Appl. No. 10/063,868

Amendments to the Drawings

Annotated Sheet
Inventor: David Crist Gabriel
Serial No.: 10/063,868
For: Diagnostic Method for an Electric Drive Assembly
Attorney Doc. No.: 201-0268

Figure 1

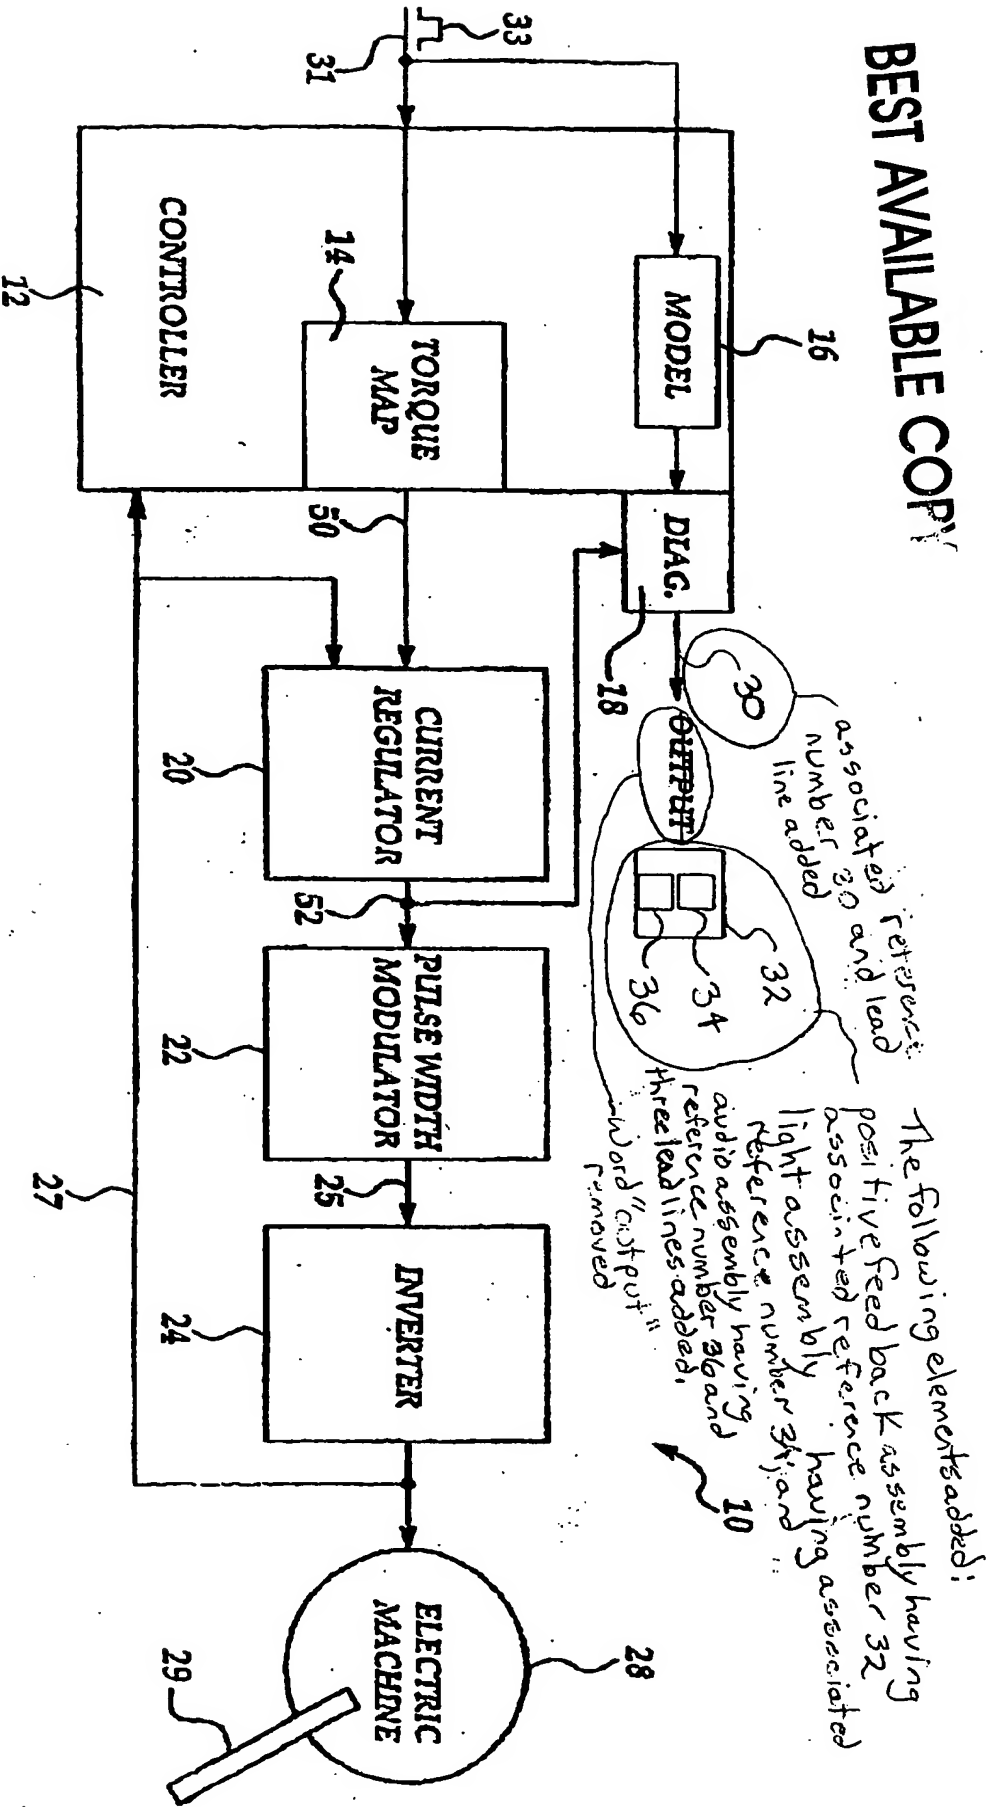
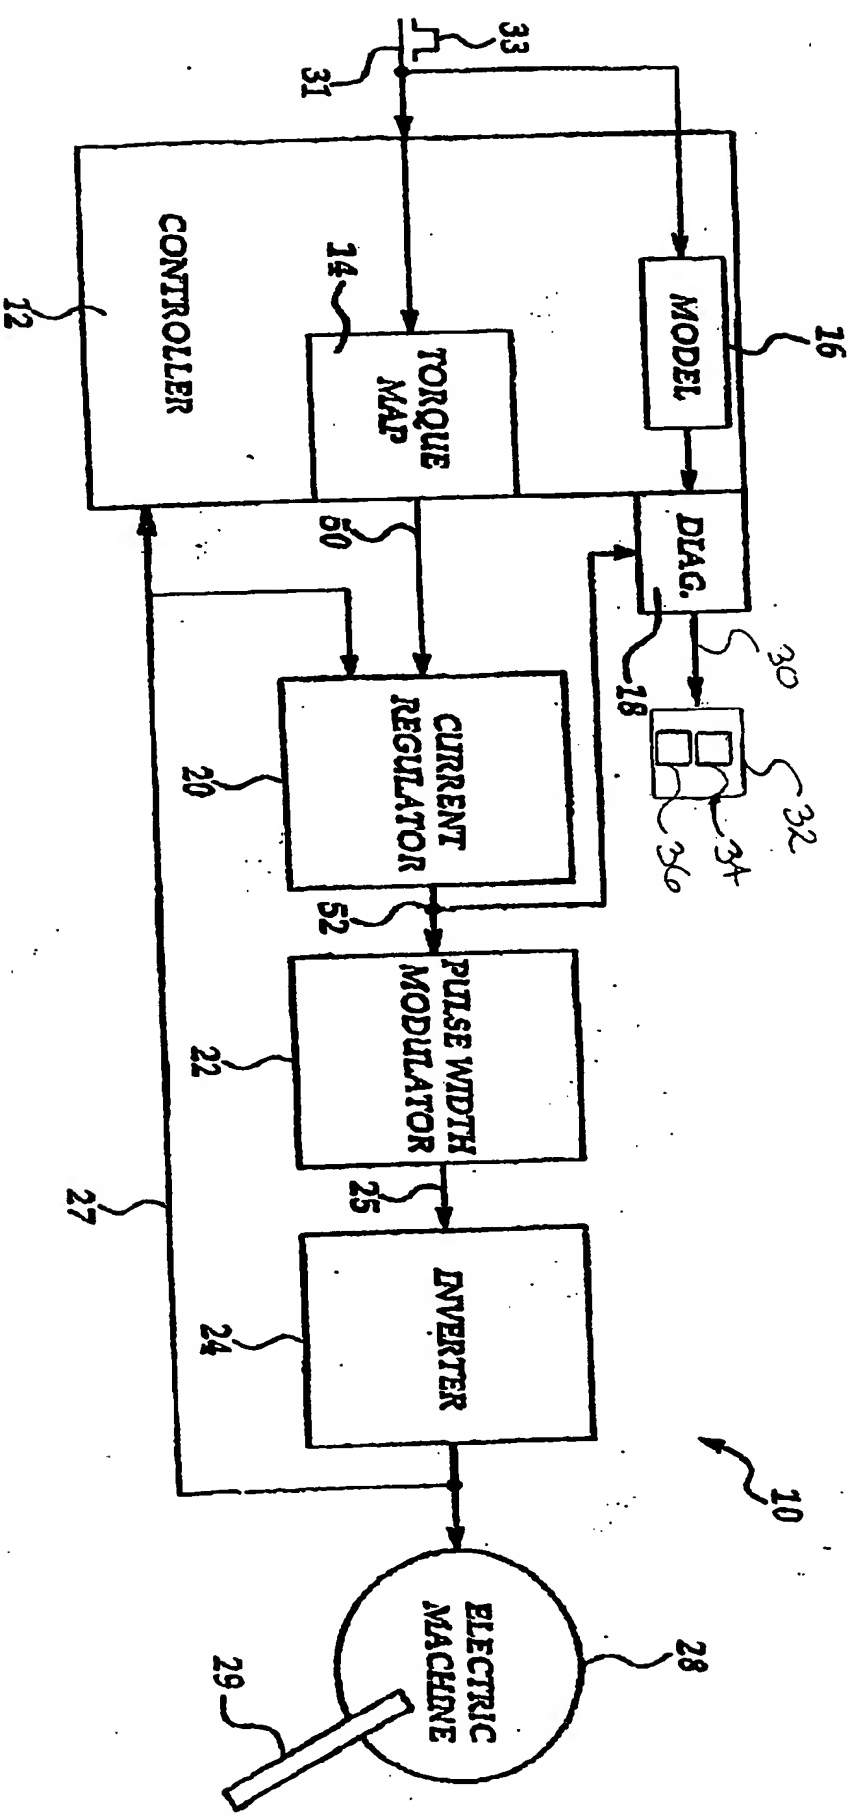
The attached sheet of drawings includes changes to Figure 1. This sheet, which includes Figure 1, replaces the original sheet including Figure 1. In amended Figure 1, a reference number 30 depicting a diagnostic output signal having an associated lead line has been added as disclosed in Pending Application, page 11, line 20, and the word "OUTPUT" has been removed. Additionally, a positive feed back assembly having associated reference number "32" and lead line has been added as disclosed in Pending Application, page 11, lines 21-22. Also, both a selectively energizable light assembly having an associated reference number "34" and lead line has been added as disclosed in Pending Application, page 12, lines 3-4; and a selectively energizable audio assembly having an associated reference number "36" and lead line has been added as disclosed in Pending Application, page 12, lines 4-5.
